Re: Structural Observation — 62 Angel Oak Drive, Bunnlevel, NC 28323

At your request, on February 3, 2022 we performed a review of the structural plan proposed by *Tarheel Basement Systems* for the foundation stabilization work at the Bunnlevel residence noted above. The structure is a conventionally framed, detached, single family residence with raised first floor framing over a pier/girder foundation system with perimeter masonry foundation walls (*see picture 1*).

*Repair schematic*

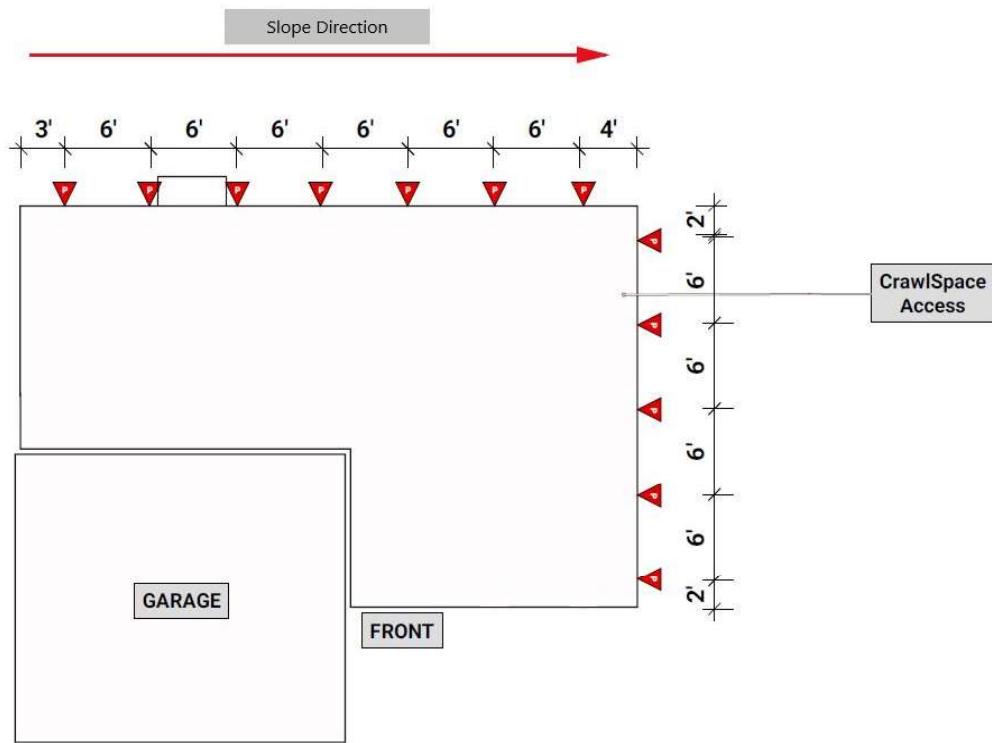
- Avoid installing piers under windows and doors
- Install piers at approximately 6' on center and at the approximate locations shown in the attached repair schematic.
